Staff Report

To: Salt Lake City Planning Commission
From: Cassie Younger, Senior Planner, cassie.younger@slcgov.com
Date: January 10, 2024
Re: PLNPCM2023-00586

Design Review

PROPERTY ADDRESS: 1665 W California Ave

BIKE RACK DETAIL

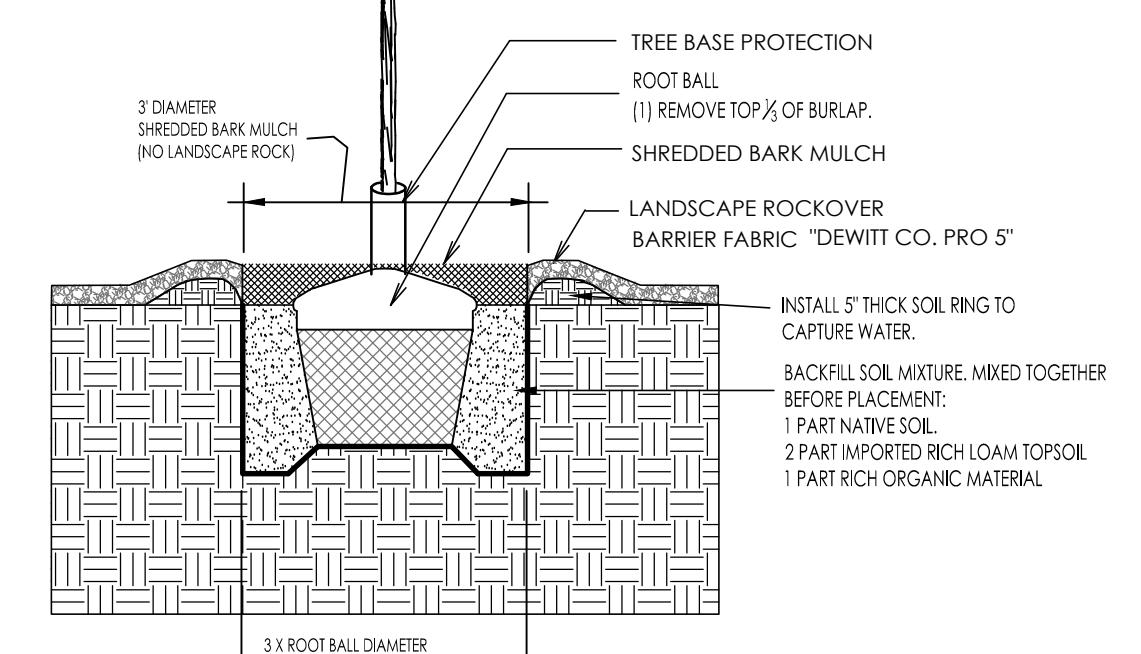
Discussion: The development has one vehicular access and allows for pedestrian and bike access to the front and side entrances of the building. The bike rack shown in the site plan needs to be updated to meet Transportation's Off-Street Parking Manual in order to receive Building Permit approval.

No transportation issues with this application. Electric vehicle and bicycle parking will be addressed at building permit stage. They will need to install racks that meet SLC standards. The bike rack requirements, including approved rack type and space required, are included in the SLC Off Street Parking Standards Manual.
